STANDARD FLOOR PLAN

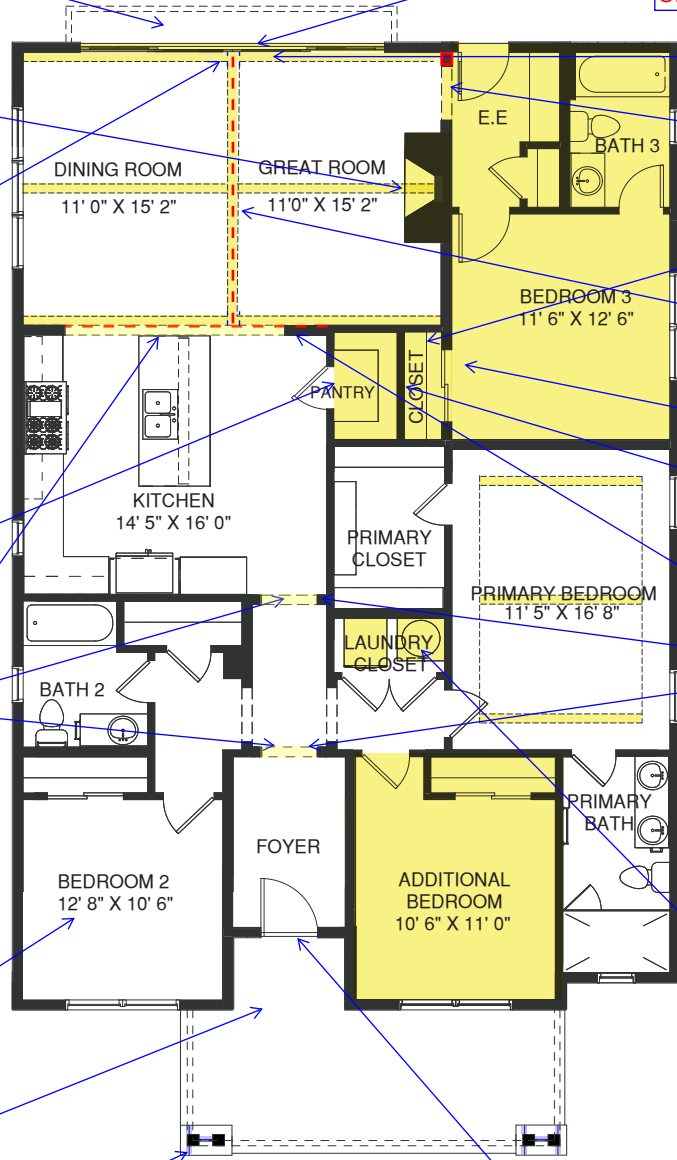
REDUCE TO SINGLE DASHED LINE RATHER THAN TWO;
(SIMILAR COMMENT ON
OPTIONAL 16080 REAR)

ADD WHITEOUT BELOW
FIREPLACE OPTION LAYER SO
IT MASKS FAUX BEAMS
OPTION AND CEILING PEAK
BELOW

CEILING BEAM OPTION - RIDGE
BEAM CONTINUOUS PAST
SECONDARY BEAMS AT BOTH
ENDS (BLUE)

ADD ROOM IN PARENTHESIS
TO CEILING BEAM OPTIONS (IN
LAYERS) TO HELP NOTE
GREAT ROOM VS. PRIMARY
BED

CLOSET/PANTRY SHOULD BE
IDENTICAL FOR "BED001" AND
"BEDBATH001"; LATTER SEEMS
CLEANER AS SOURCE OF
TRUTH

HIGHLIGHT FOR
"CASEOPN001" (COMBINE TWO
CASED OPENING OPTIONS
INTO ONE LAYER)

SPANISH: KEEP 10'-6"
DIMENSION FIRST AND 12'-8"
DIMENSION SECOND AT BED 2

CRAFTSMAN: HIDE PORCH
LINE AS PORCH EXTENDS
OUT.

CRAFTSMAN: DELETE EXTRA
LINES AROUND COLUMNS AT
EACH SIDE (BLUE)

SHIFT EXTERIOR LINE OF
SLIDER SILL TO ALIGN WITH
EXTERIOR FACE OF WALL;
DELETE INTERIOR SILL LINE
(SIMILAR COMMENT ON
OPTIONAL 16080 REAR)

DELETE FLOATING SOLID LINE
(DISAPPEARS WHEN I ZOOM IN
SO NOT SURE)

ADD WALL AT CASED OPENING
FOR "BED001" (SEE
"BEDBATH001")

MASK DOOR LINE FOR
"BED001"

SHOW DASHED LINE FOR
VAULTED CEILING PEAK IN
BASE HOUSE (SHOULD GET
MASKED BY CEILING BEAM
OPTION)

DOOR SHOULD BE INSWING;
ALSO CHECK WALL HATCH
AROUND DOOR

ADD PERIOD TO SECOND E
("E.E")

HIDE ALL DASHED LINES FOR
BASE HOUSE (AT THIS
OPENING) WHEN
"CASEOPN001" IS NOT
SELECTED EXCEPT FOR ONE
RED DASHED LINE
SEPARATING FLAT CEILING
FROM VAULT IN GREAT ROOM

EXPAND BLACK HATCH IN
WALLS OUT TO EXTERIOR
LINE, TYP. ALL EXT. WALLS

RIGHT CIRCLE IS HOT WATER
HEATER (MOVE TO BASE
GEOMETRY); ONLY ADD AND
HIGHLIGHT LOWER
RECTANGLE BLOCK FOR
"LNRYWD0001"; REMOVE
DASHED LINE INDICATING
UPPER CABINETS

SHOW SINGLE SOLID LINE AT EXTERIOR
FACE OF WALL FOR STEP/SILL (ALL
ELEVATIONS); ENTRY DOOR ALSO SHIFTS
ACROSS ELEVATIONS - KEEP AT
INTERIOR FACE OF WALL
